NSLPP MEETING HELD ON 05/10/22

ADDRESS/WARD: 5 (formerly 1-11) Rodborough Avenue, Crows Nest

APPLICATION No: DA 232/2020/3

PROPOSAL: Section 4.55(2) modification relating to Development Consent D 232/20 for the demolition of the existing buildings and the construction of a 4 storey residential flat building with basement parking and associated landscaping including strata subdivision.

Figure 1. DA232/2020/3 s4.55(2) modification amended proposed roof plan

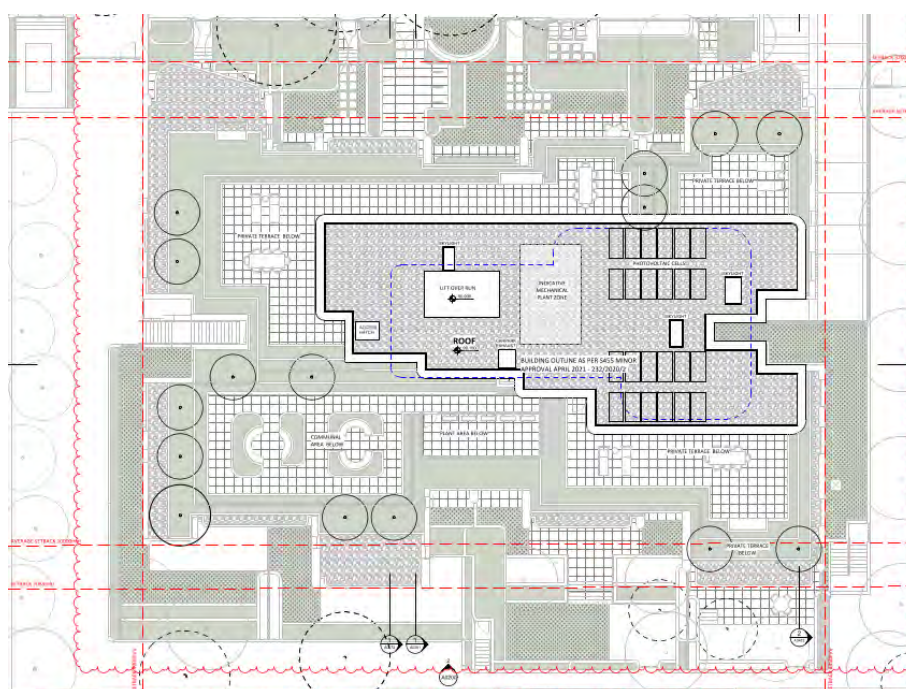
The proposed additional apartment on the upper most level also results in a loss of approximately half of the roof top communal open space and comes at a detriment to the amenity of the approved development.

The proposed modification would reduce the size of the approved communal roof top open space area by privatising a portion of this space to achieve additional development yield. The proposed modification is therefore detrimental to the potential for social interaction between residents within the development.

Figure 13. DA232/2020/3 s4.55(2) modification amended proposed roof plan (subject of this report) with two units on level 3

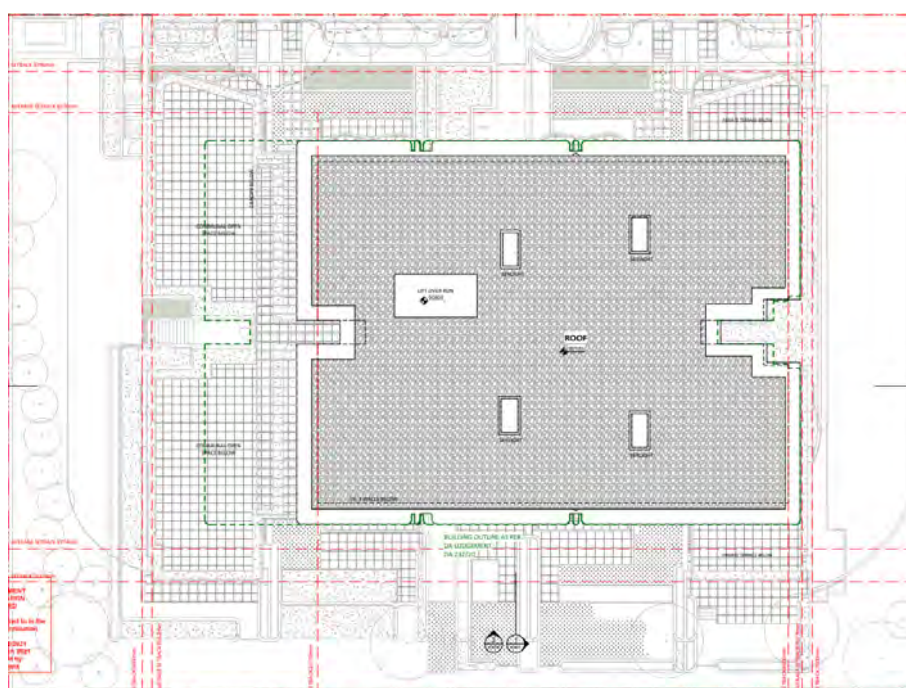
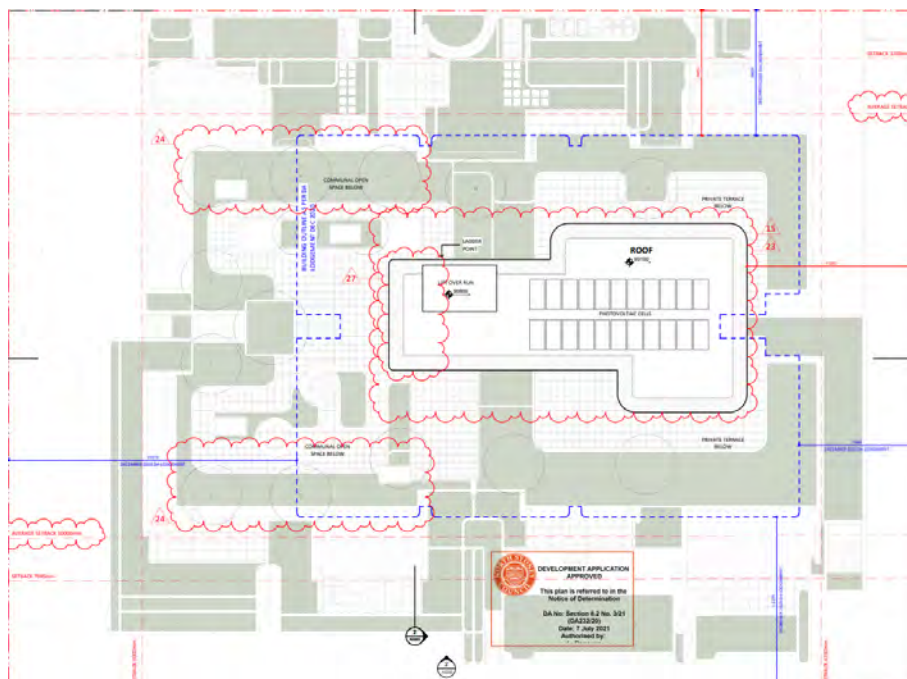
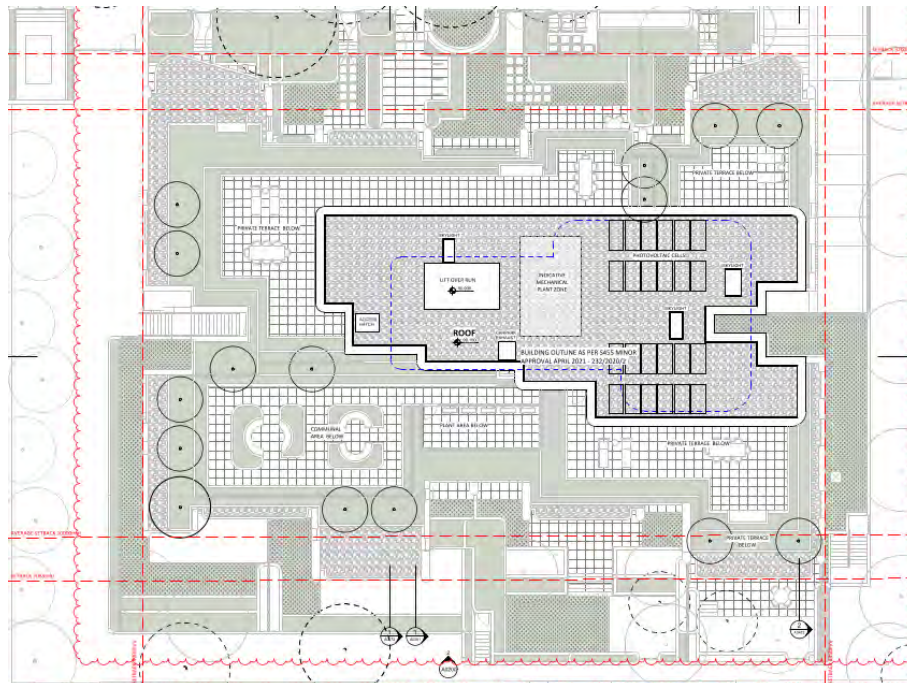
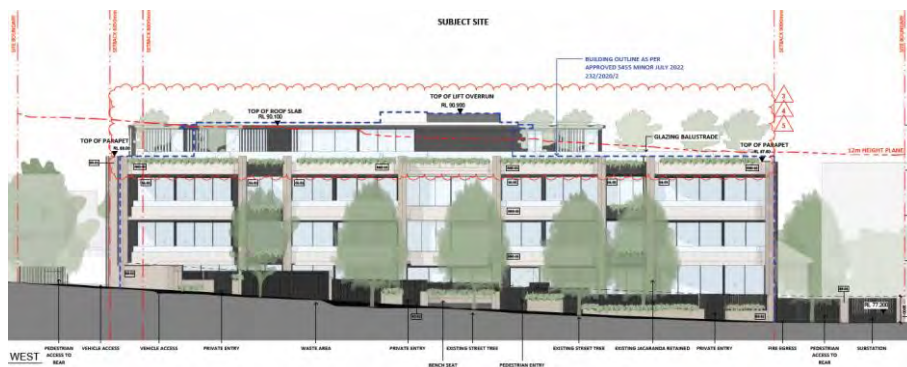
The proposed modified development would be inconsistent with the reasons for approval provided by the Panel given that the development again seeks additional yield on the originally refused third floor level where the excessive non-compliance with the height of building development standard occurs. Furthermore, the proposed modified development seeks to increase the number of dwellings with an increase from 27 (s8.2 approved), to 28 apartments and there is also an associated increase in parking.

It is evident that the proposed additional massing on the upper most level caused by the proposed additional apartment has been conceived through a process of reductions from the originally proposed scheme in an effort to comply with relevant numerical development controls and not as an architectural response to the building. The proposed additional massing is elongated in form and is poorly proportioned with extensive blank facades and various irregular articulations. There is limited consistency in the size and scale of the proposed upper level. The reduced set back from the level below on the northern side of the building results in additional visual massing when viewed from the north.

The western elevation of the upper most level is a long (32m) single plane of curtain wall glazing or blank wall and has no physical articulation and very limited visual articulation. There is also no eave proposed to provide any significant degree of architectural detailing to this element.

Figure 17. Height Plane Diagram

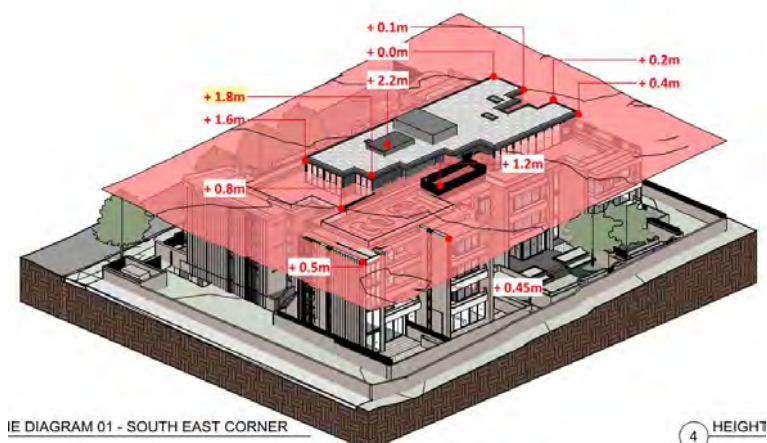
The proposed modification would further exacerbate the contravention by increasing the extent of the floor plate that exceeds the height plane.

The proposed modified building form has a maximum height of 13.8m, a variation of **1.8m** or **15%**. The largest extent of the variation occurs within the southeastern corner of the upper most level.

The proposed modification also includes an additional mechanical plant enclosure zone on top of the roof adjacent to the lift overrun which would have a maximum height of approximately **14.5m**, a variation of **2.5m** or **20.83%**. The approved development had a larger plant area on the level below that was well integrated with the building form, although this area is proposed to be subsumed for additional floor space.

Figure 18. Approved Development - View from sun solar diagram 3:00pm in midwinter

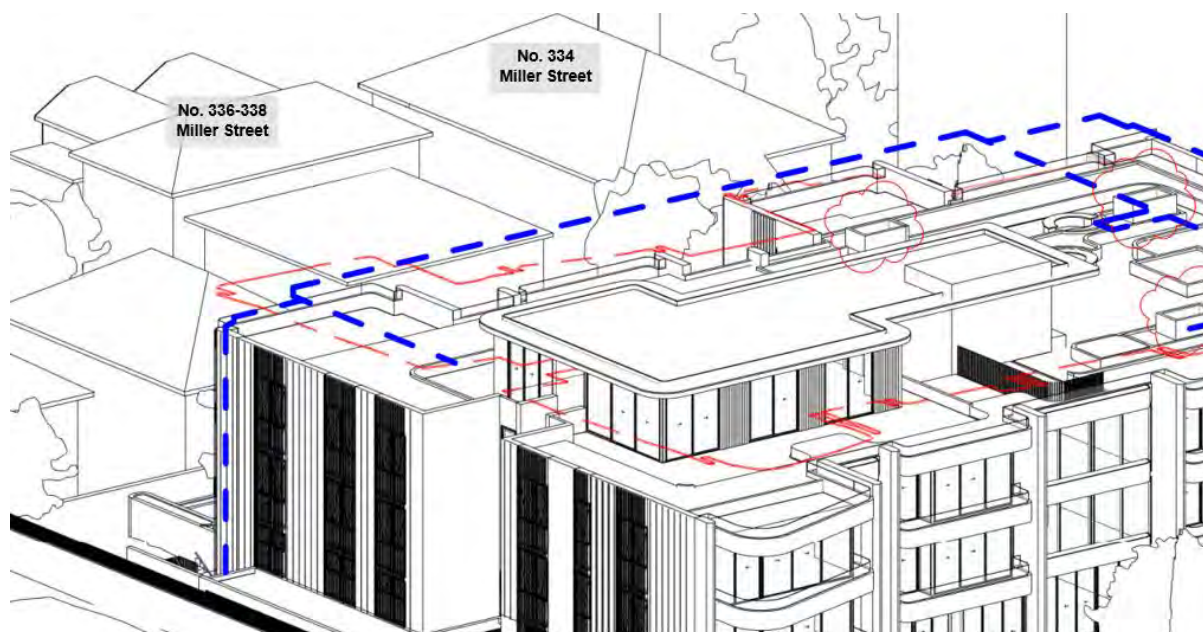
The submitted shadow diagrams do not delineate potential shadowing caused by the compliant or non-compliant elements. Notwithstanding, the proposed modified development would result in some very minor additional overshadowing of the adjoining properties to the east (Nos. 334 & 336-338 Miller Street). The overshadowing would impact the west facing ground level communal open space between 2pm and 3pm in mid-winter and the west facing ground and first floor windows by 3pm.

The design of the proposed upper level area additional aligns with the existing shadowing impact at 3:00pm in mid-winter. Some minor additional overshadowing would arise as a result of the proposed modification. Whilst the additional impact on the amenity of the adjoining dwellings would be minor, the approved development already causes a notable impact to these properties in the afternoon hours.

DWG TITLE
LEVEL 03 FLOOR PLAN

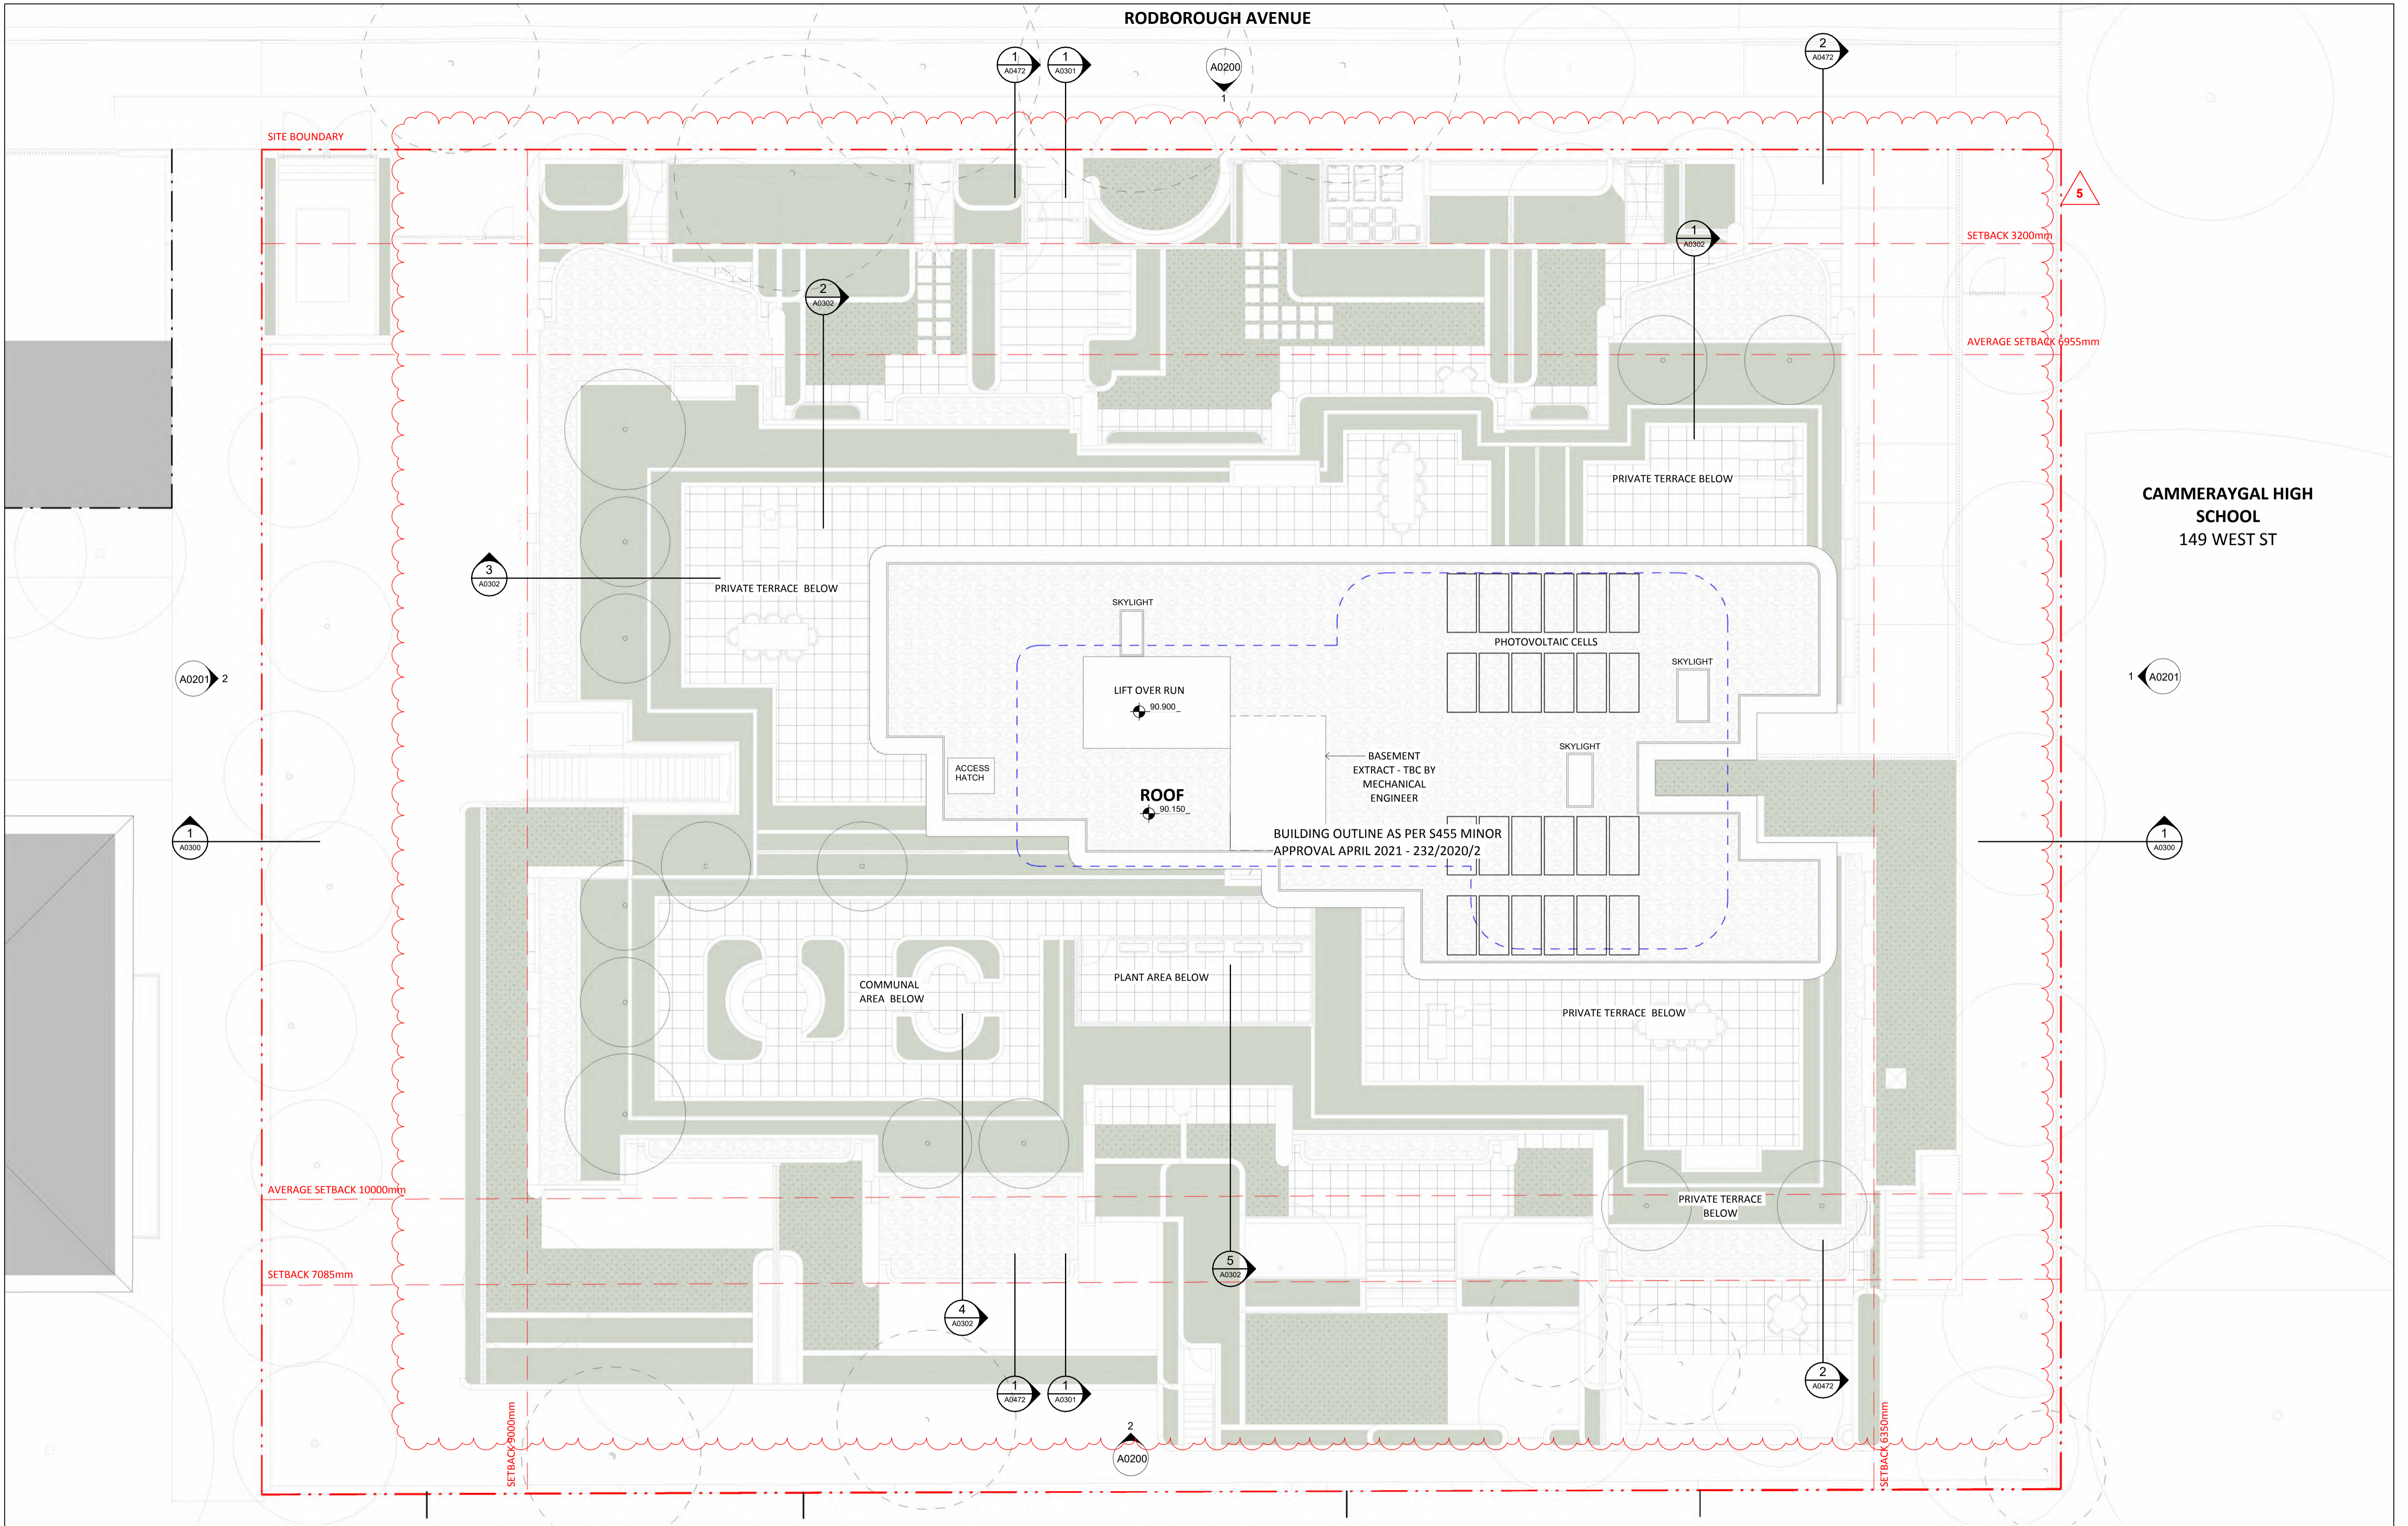
It is noted that the proposed modified scheme extends the upper most level (level 03) a further 7m to the south in comparison to the approved development, with additional massing surrounding the left core which was intended to be a recessive element. The length of the building, and more specifically the upper most level (32m), is significant when viewed from the street and the highlights the lack of variation (stepping) in the building form and the resulting disassociation with the slope of the site, particularly when viewed in comparison to the footpath level.
